MEMORANDUM

JOB NAME: #17-254022 FA adidas NACCO Warehouse
Portland, OR

RE: Scope and Submission Changes

RE: Scope and Submission Changes

3 FIRST FLOOR OCCUPANCY
G-101 1/16" = 1'-0"

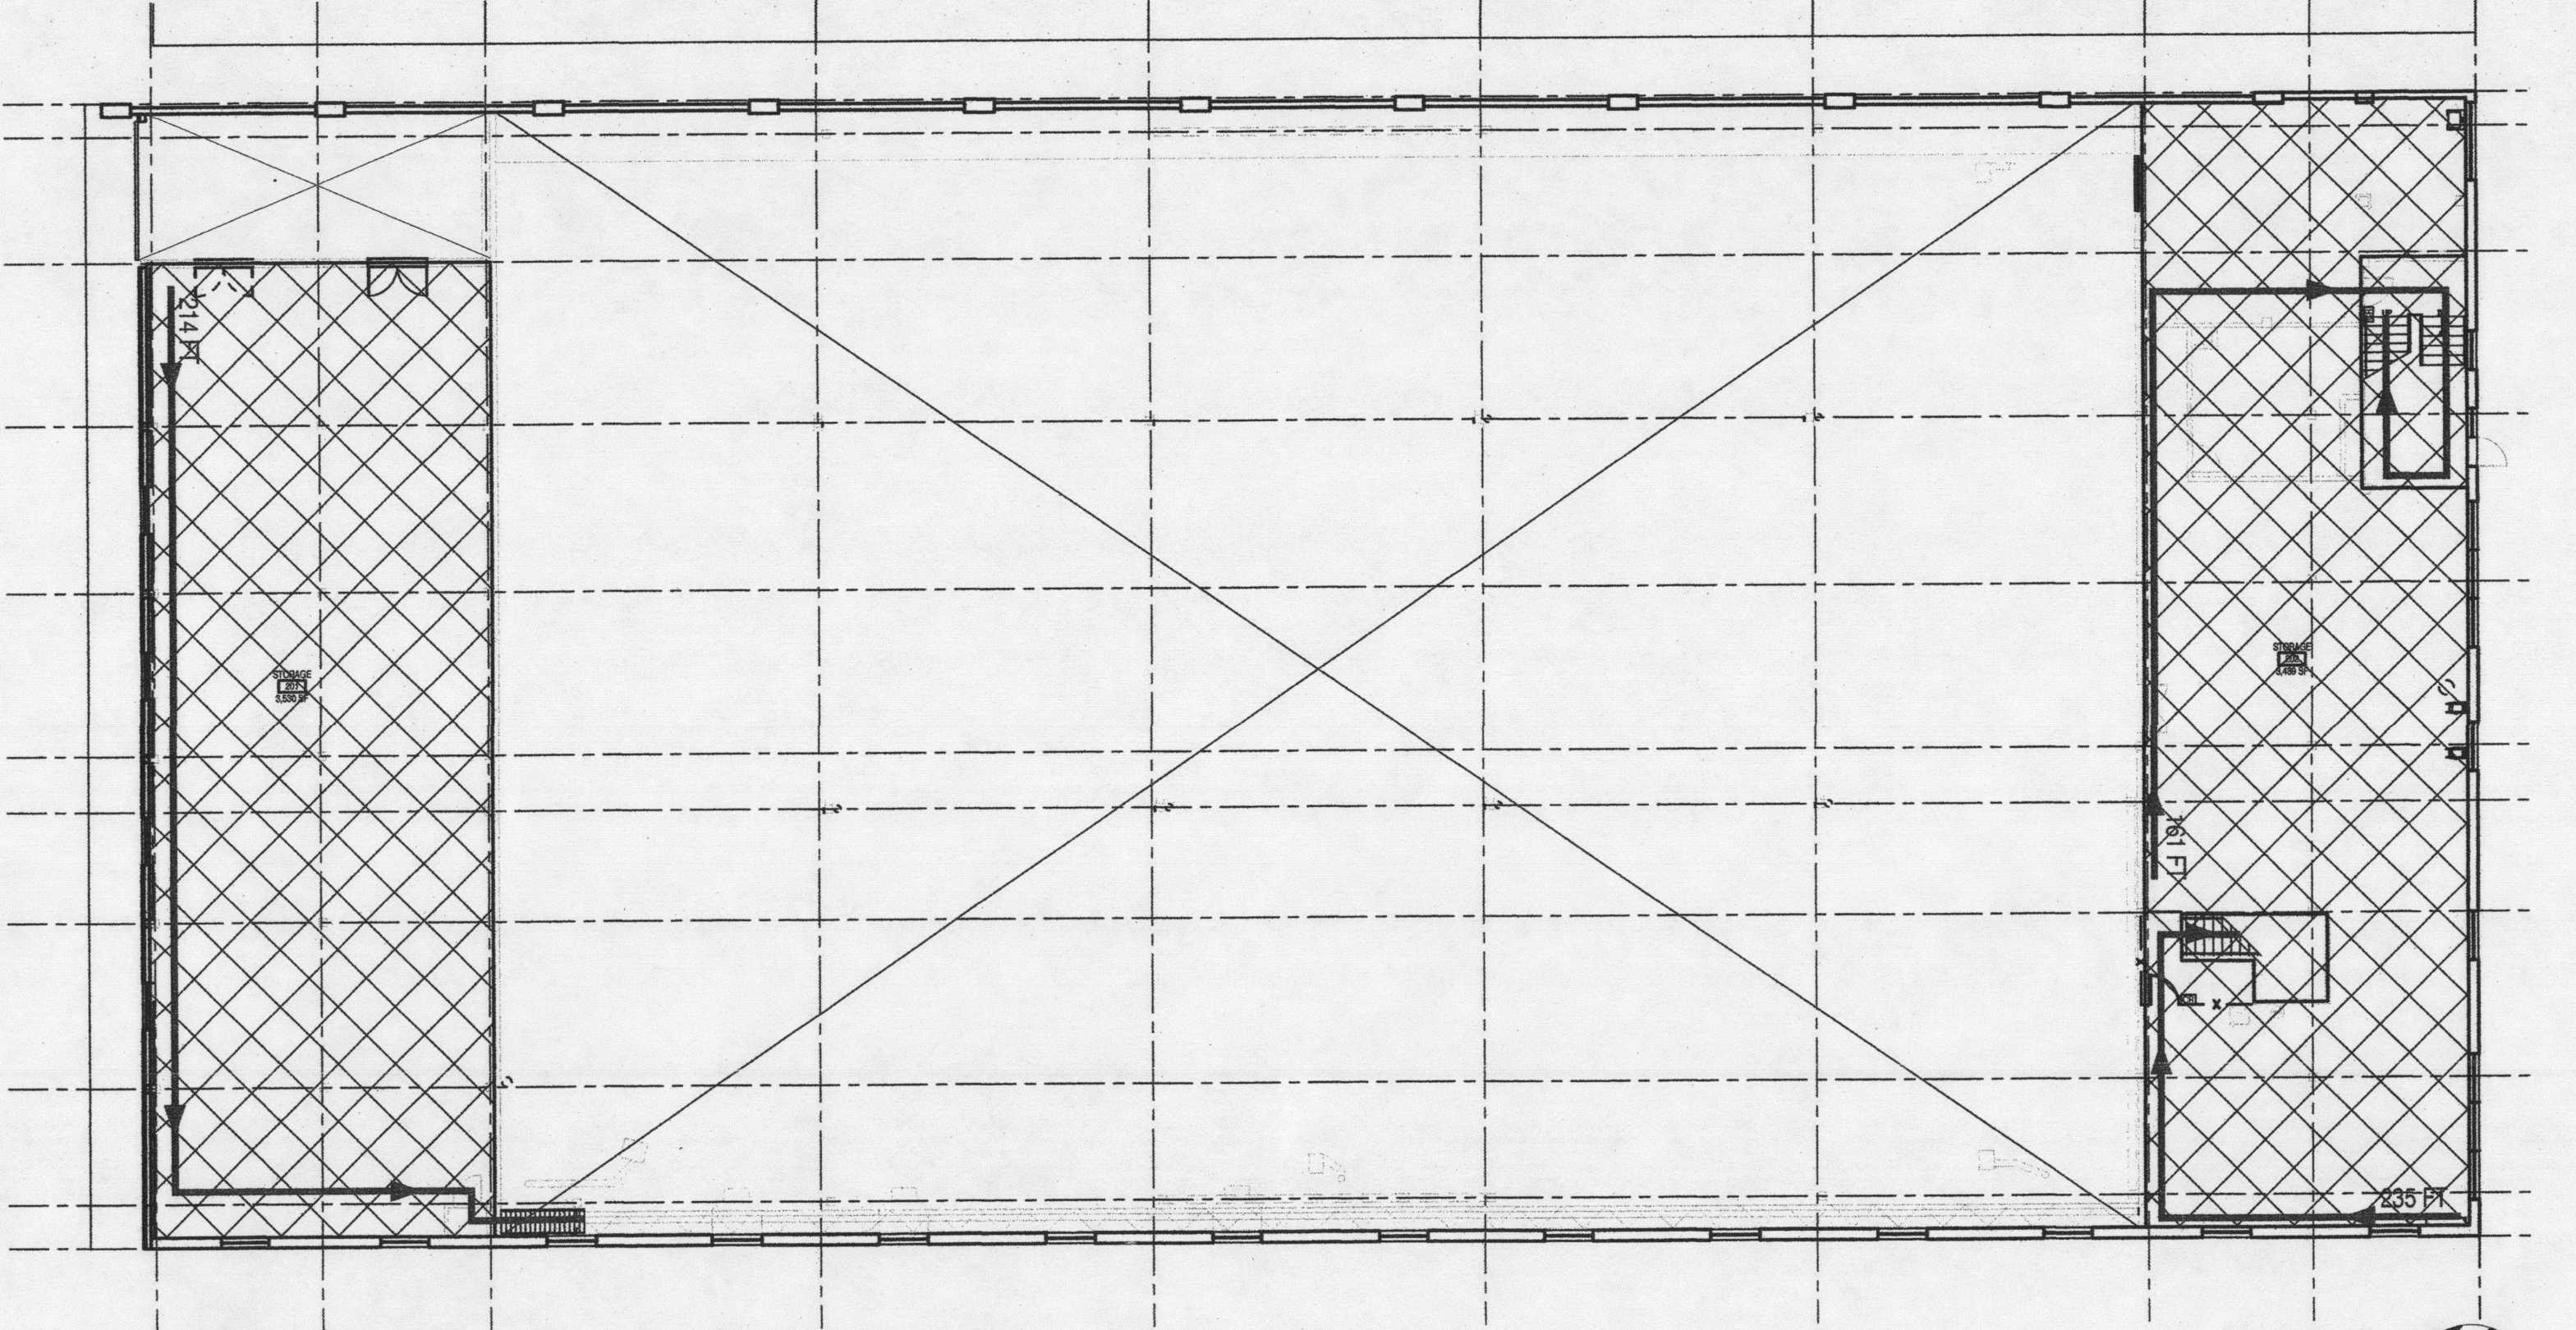
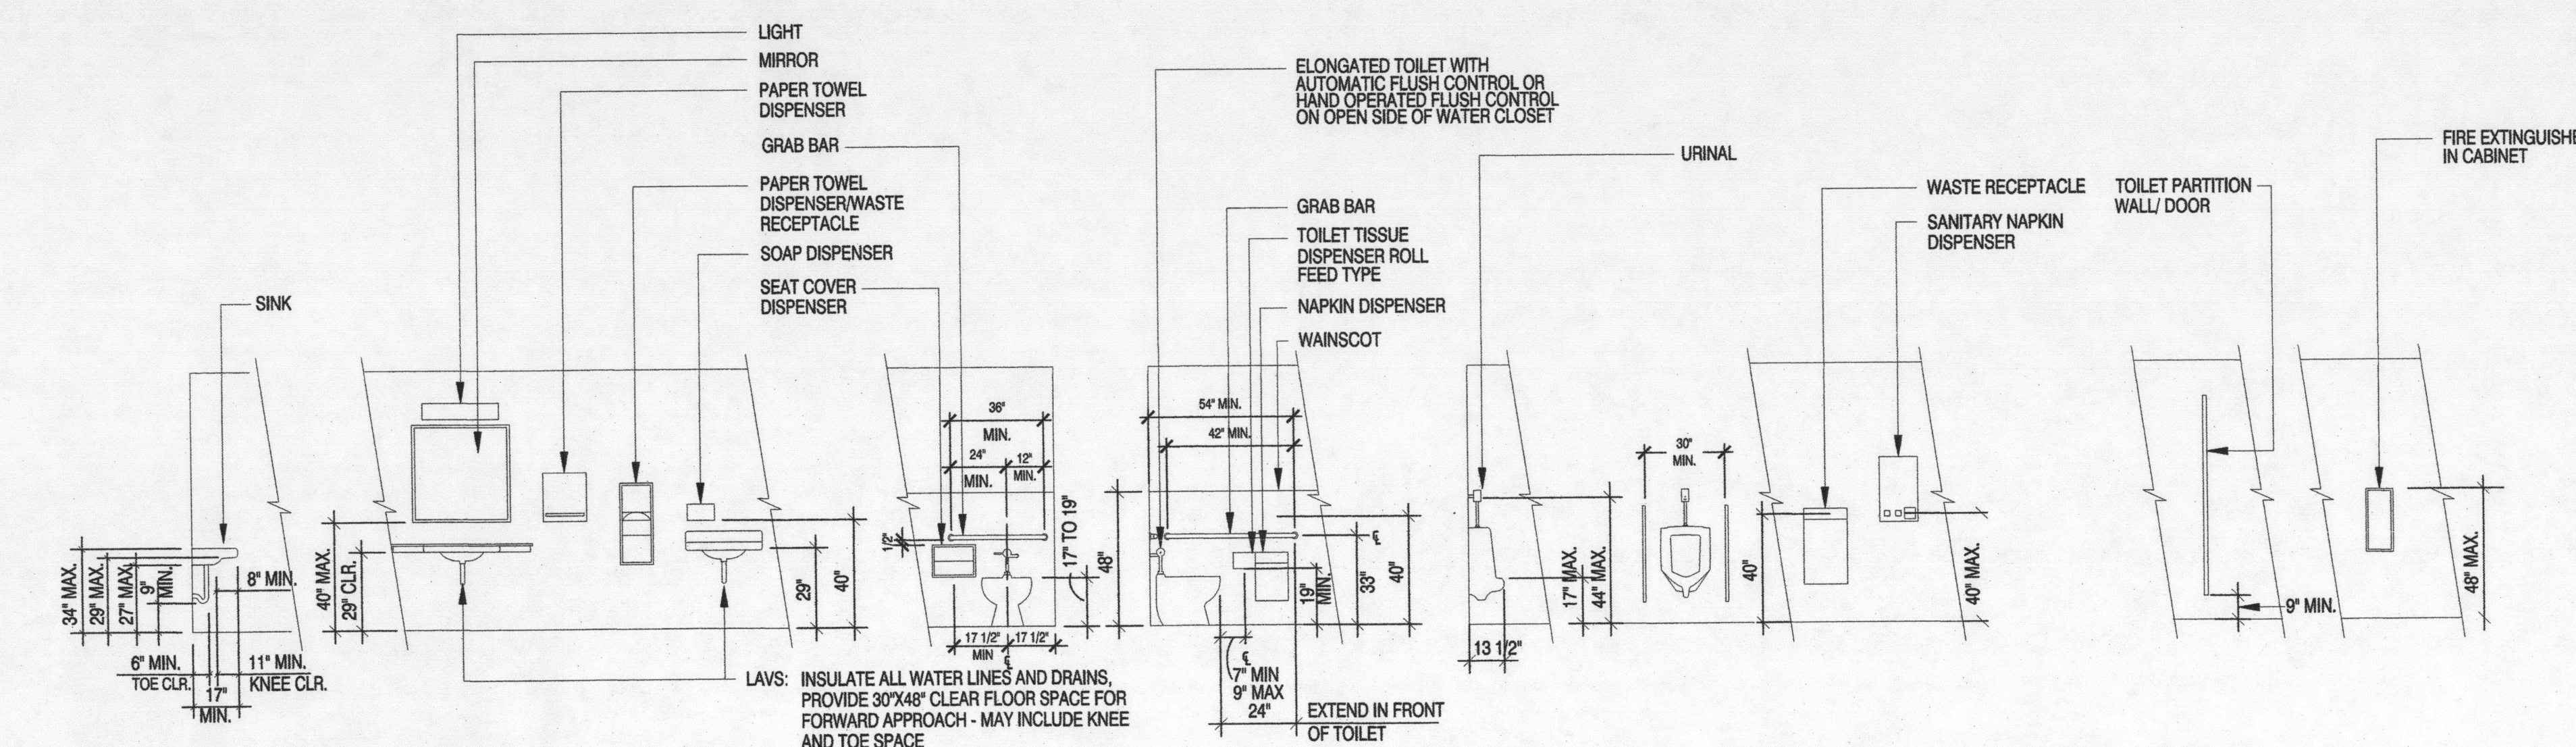
G-101	Modified Egress, calculations
A-101	Modified Parking, parking calculations
A-200	Modified to show full scope
A-202	Modified to show full scope, additional security fence, shelving
A-203	Modified due to scope
A-204	Modified due to scope
A-205	Modified to show full scope
A-206	Modified to show full scope
A-207	Modified to show full scope
A-400	Modified to show full scope, additional security wall
A-500	Removed due to change in security wall
A-600	Modified door schedule
A-700	Modified details

1 DEMOLITION PLAN - FIRST FLOOR
A-200 1/8" = 1'-0"

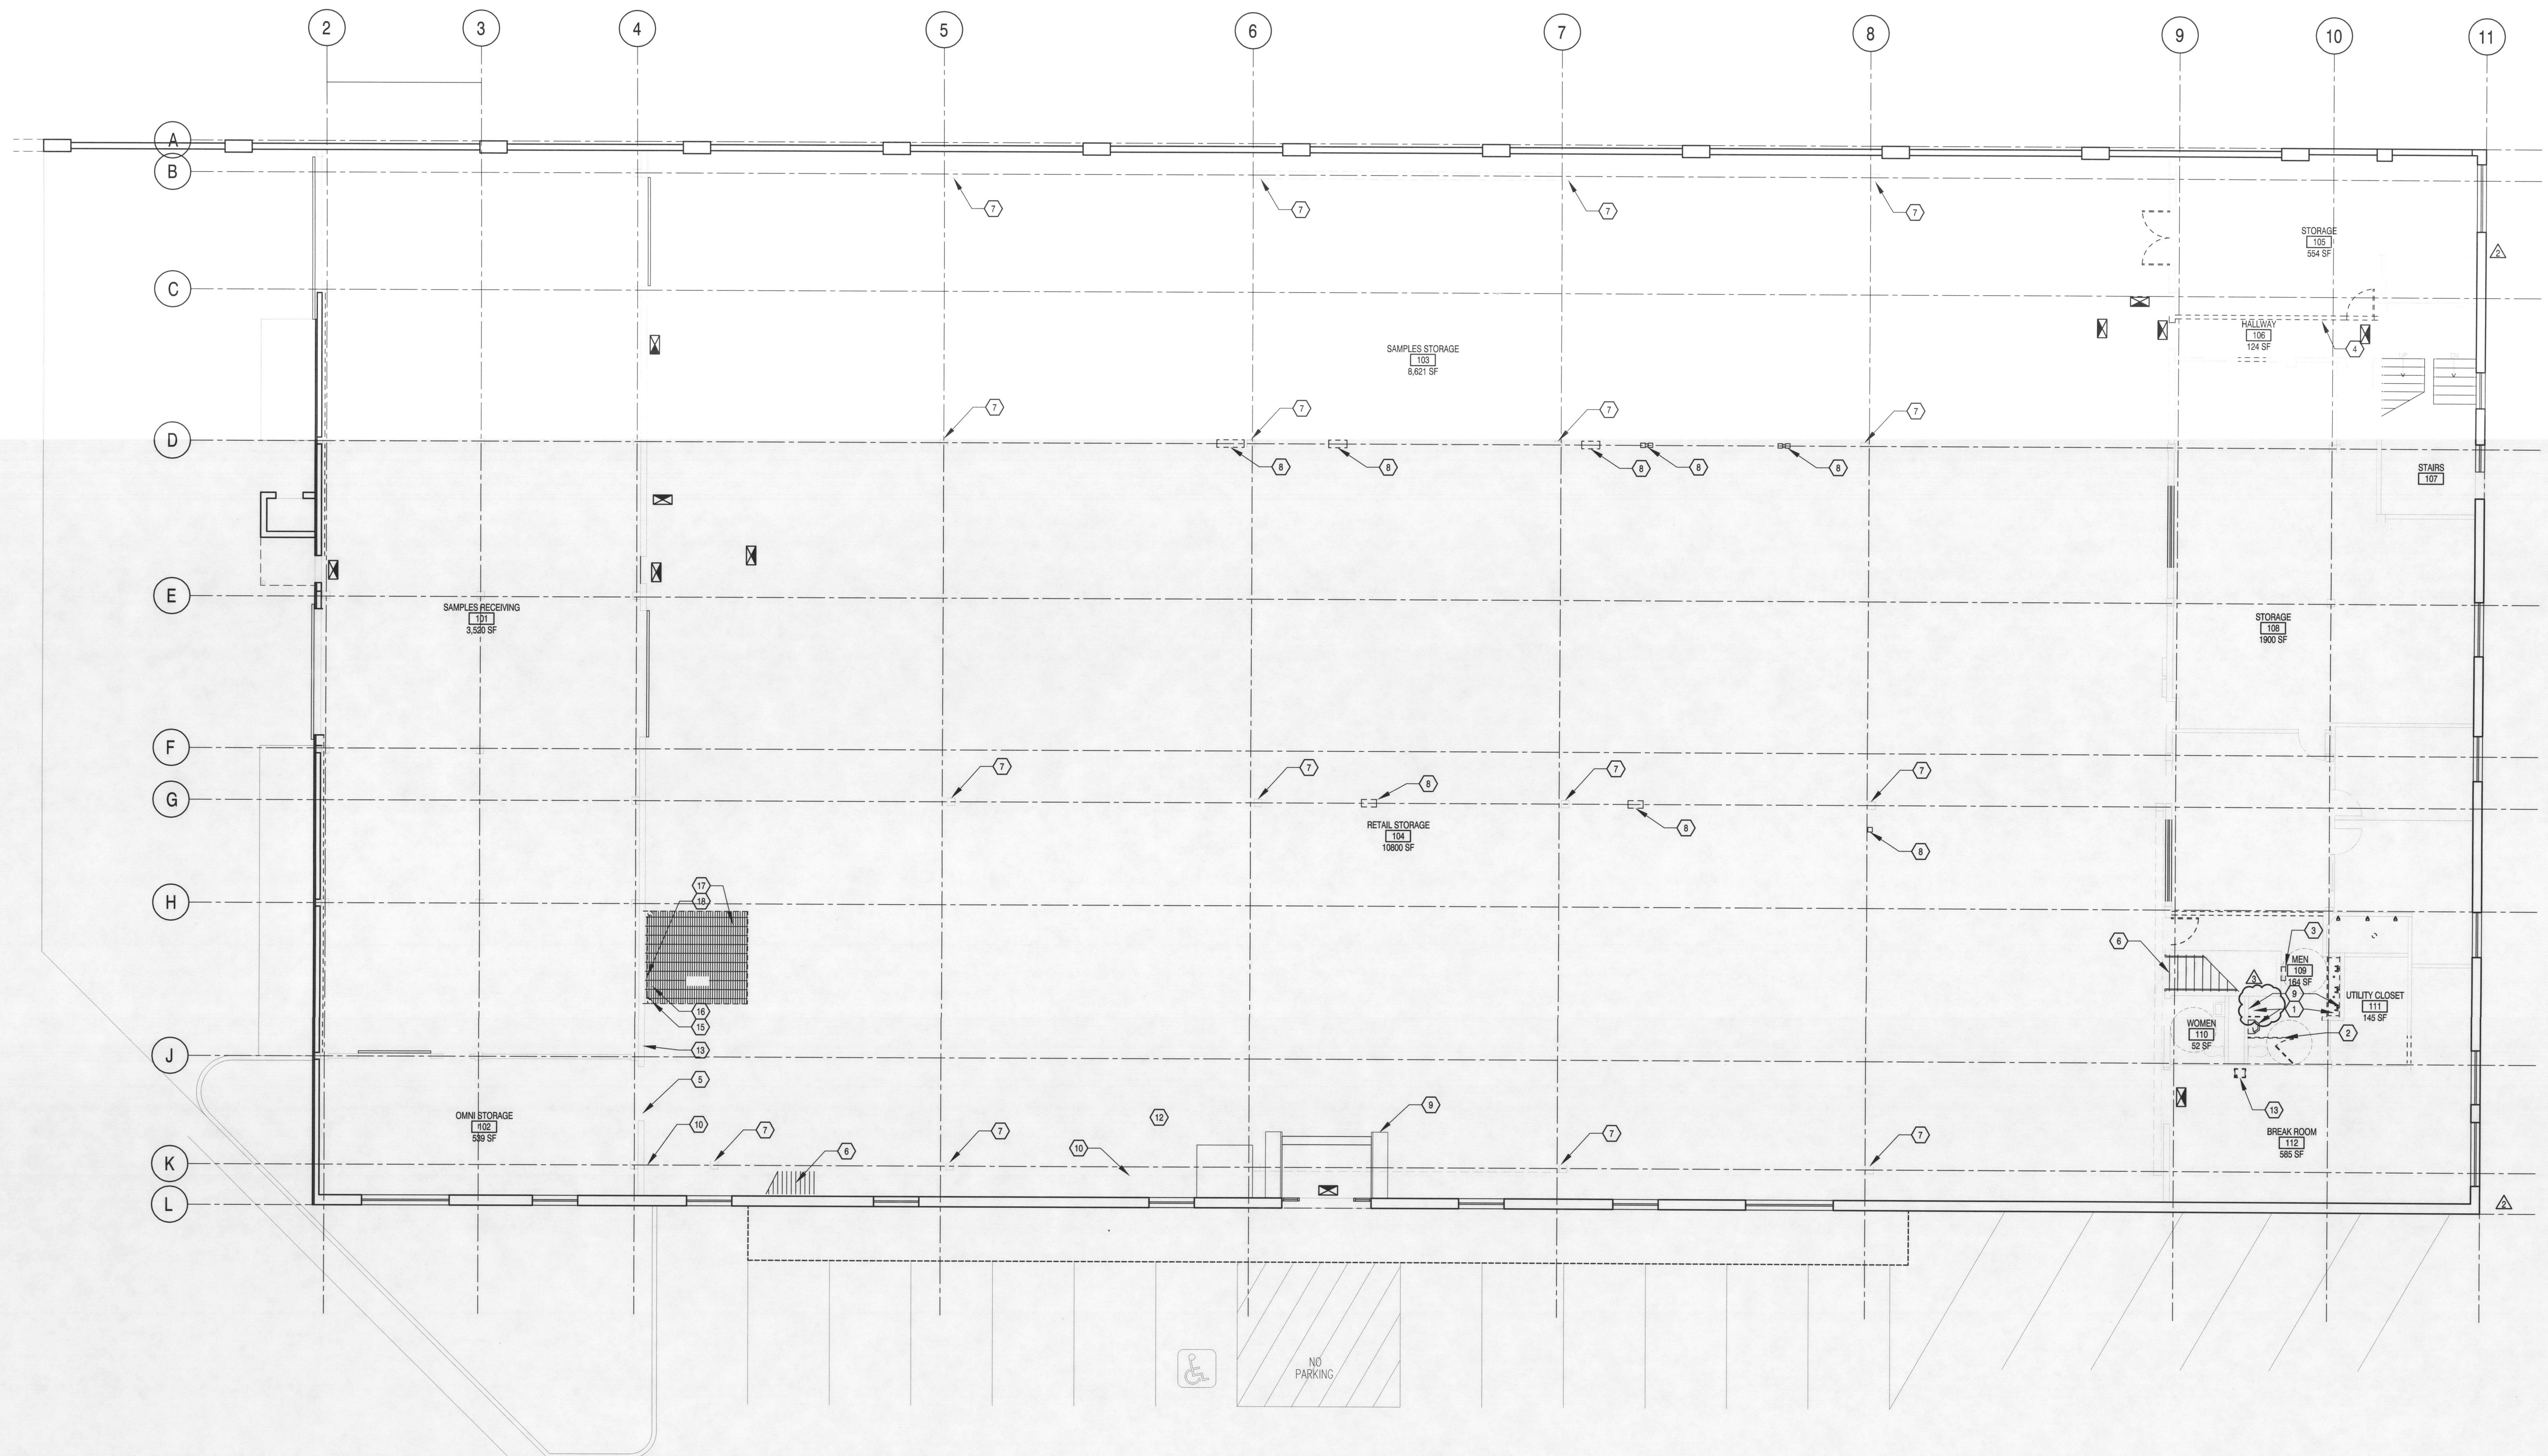
A-200	Revised to show removal of urinal
A-202	Revised to show new racking layout, no partition in men's restroom
A-600	Revised elevations, door schedule
